FM RADIO STATIC HEARD BETWEEN 88 TO 97 MHZ

G05 (X5 Sports Activity Vehicle)	G12 (7 Series Sedan)	G15 (8 Series Coupe)	G30 (5 Series Sedan)
G32 (640i Gran Turismo)	I12 (i8 Coupe)

Vehicles produced from July 1, 2018 to November 5, 2018

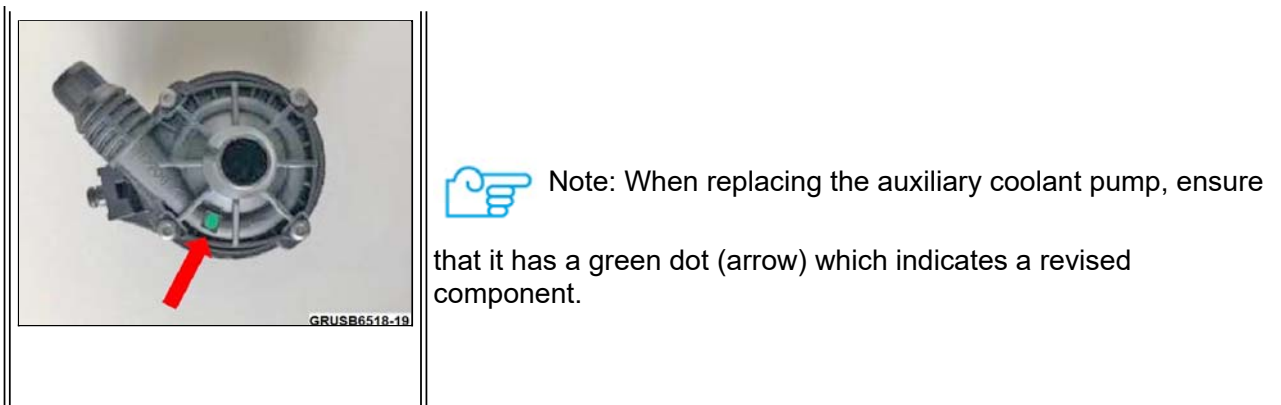
YES - If the static is reproducible with the engine running, check the part number of the auxiliary coolant pump.

If it is one of the part numbers below, the auxiliary coolant pump must be replaced:

- 11 51 8 679 885
- 64 11 6 834 923
- 11 51 8 671 654

3. Follow Repair Instructions REP 64 11 262 "Removing and installing/replacing the coolant pump".
4. After installation of the new auxiliary coolant pump, bleed the cooling system.
 - **For all models except I12:** Follow SI [B17 01 10](#) "Proper evacuation and/or filling of cooling system after repairs"
 - **For I12 only:** Follow SI [B17 02 18](#) "Proper coolant bleeding procedure"
5. Verify the absence of radio static interference on the FM band after moving the vehicle outdoors.
